PERFORMANCE • DEPENDABILITY
HOMELITE
 SERVICE

TO: All Homelite Branches and Chain Saw Dealers

SUBJECT: A-56613 Exhaust Cap and Muffler Element

BRANCH SERVICE MEMO NO. 270a-CS

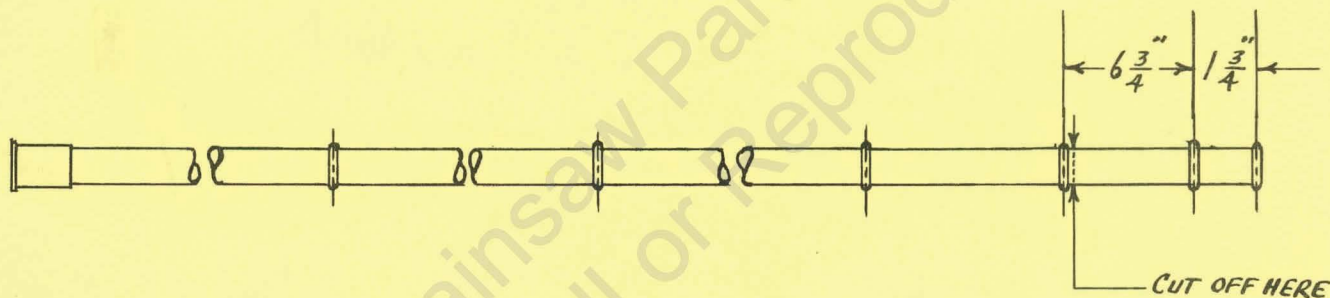
The service life of the flexible shaft and casing in Brushcutters can be extended by reducing the length of the casing.

Starting immediately, we will supply casing Part No. A-55458-1 in place of A-55458. Part No. A-55458-1 is produced by cutting $8\frac{1}{2}$ " off the end of casing A-55458 as shown below:

" To service all Brushcutters, starting immediately, use A-55458-1 Casing in place of A-55458 -- Use A-57290 Casing after A-55458-1 stock is used up."

Any A-55458 casings in your stock should be reworked by cutting $8\frac{1}{2}$ " off the lower end -- remove burrs on inside of casing after cutting.

SUBJECT: Oil Pump Service Kit, Part No. A-57615 for the Model 500 Saw Oil Pump

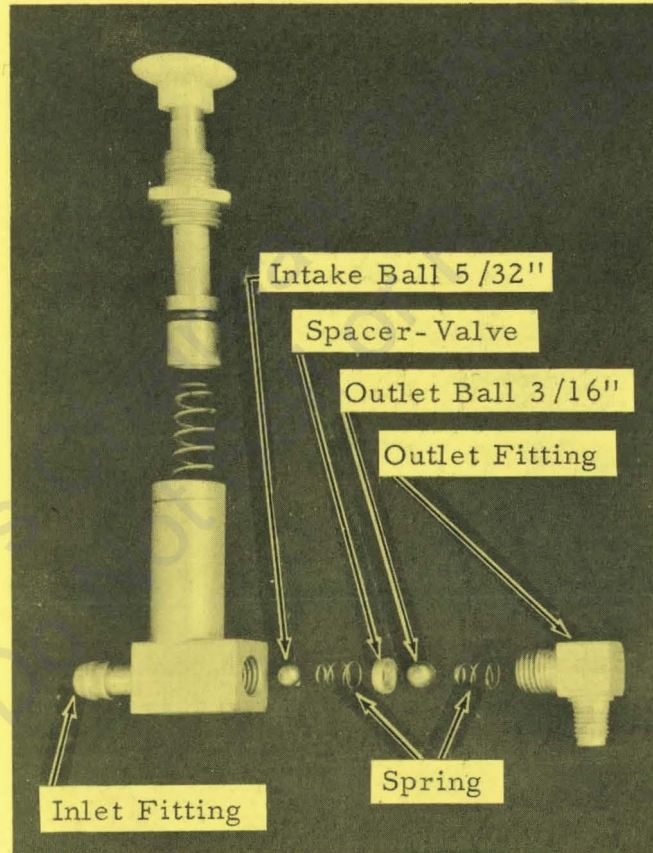
Kit, Part No. A-57615 is now available. The kit contains two check balls, two springs and a spacer-valve. These items are illustrated and called out in the sketch below.

To remove old parts unscrew the elbow outlet fitting. Insert a drift pin through the opening in the inlet fitting and press or drive out the intake ball, spring and spacer-valve.

To reassemble, install small ball; one spring (the two springs are identical) with small end toward ball, and then the spacer-valve.

NOTE: One side of the spacer-valve is countersunk.

Countersunk side provides seat for outlet ball

The spacer-valve must be pressed home with the countersunk side facing out, toward the outlet fitting.

Drop the large ball in against the spacer-valve seat; assemble remaining spring (small end on ball); reassemble outlet fitting.
